UNITED STATES PATENT AND TRADEMARK OFFICE

APPLICATION NO.	FILING DATE	FIRST NAMED INVENTOR	ATTORNEY DOCKET NO.	CONFIRMATION NO.
09/660,812	09/12/2000	Kenny L. Dang	ACS 54573 (23111)	8165

# Office Action Summary

## DETAILED ACTION

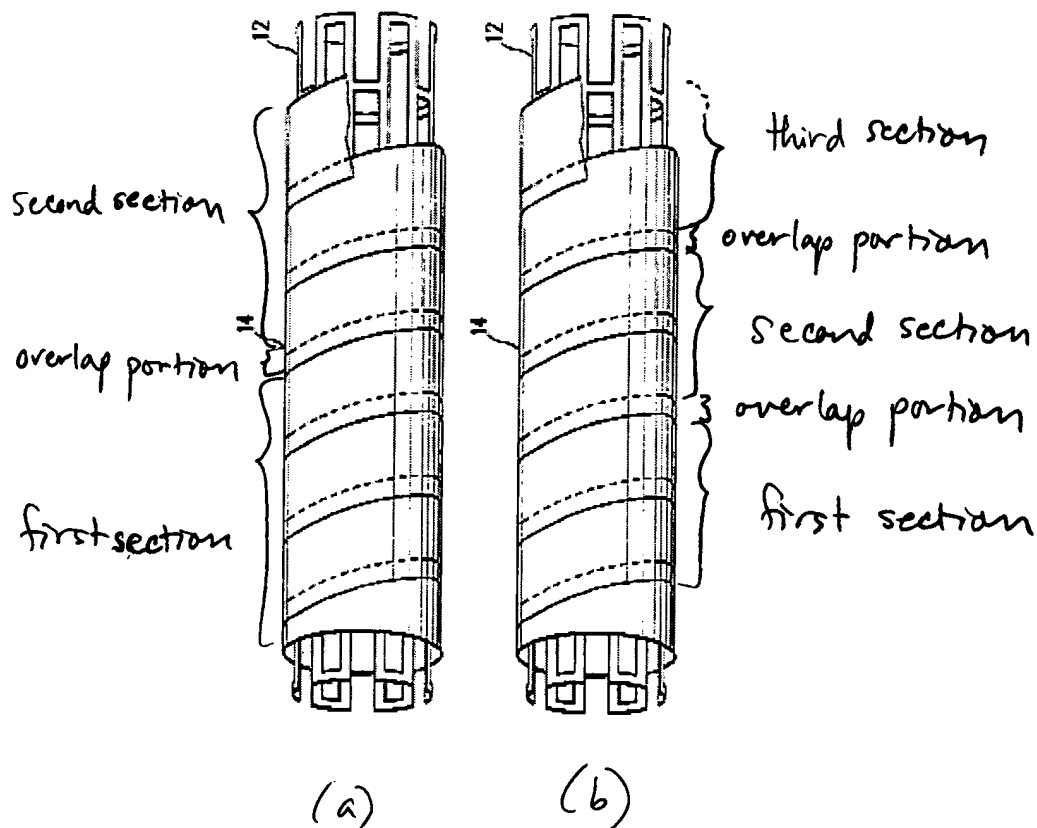
Freidberg discloses a jacketed stent assembly comprising an expandable stent jacketed with a cylinder of biocompatible, non-thrombogenic expandable material with all the elements of claims 1 and 20. See Figure 7(a) below and columns 5-6, lines 63-6 for an intravascular stent (12) having proximal and distal ends and a tubular cover material (14) covering at least a portion of the stent. The cover material has first section and a second section, each with proximal and distal ends, wherein the proximal end of the second section forms an overlap portion with the distal end of the first section. See Figure 7(a) below.

Claims 2-4 and 21-23, see Figure 7(a) above and column 4, lines 5-8 for cover material distal and proximal ends being attached to the stent and the overlap portion being positioned there-between.

Claims 7-9 and 26, 27 and 29, see Figure 7(a) above. The first three complete wraps is the first section and the next 2+ wraps is the second section, both having proximal and distal ends and both being shorter than the overall length of the stent. The first section and second section overlap and are configured for sliding movement at the overlap portion when the stent is expanded (column 6, lines 1-6).

Claims 17-18 and 36-37, see Figure 7(b) above. The first two complete wraps is the first section, the next two complete wraps is the second section, and the next 1+ wrap is the third section. Between the sections is an overlap section, so that there is more than one overlap portion along the stent.

16. The word "section" is defined by Webster's II New Riverside University Dictionary to be: "a part or piece of something; portion". A section does not require that it be separate from the whole. Therefore, the first and second sections can be interpreted to be any arbitrary portions of the tubular cover that meet the limitation of the proximal end of the second section forming an overlap with the distal end of the first section. This is clearly shown by Freidberg, as indicated in Figure 7(a) above.
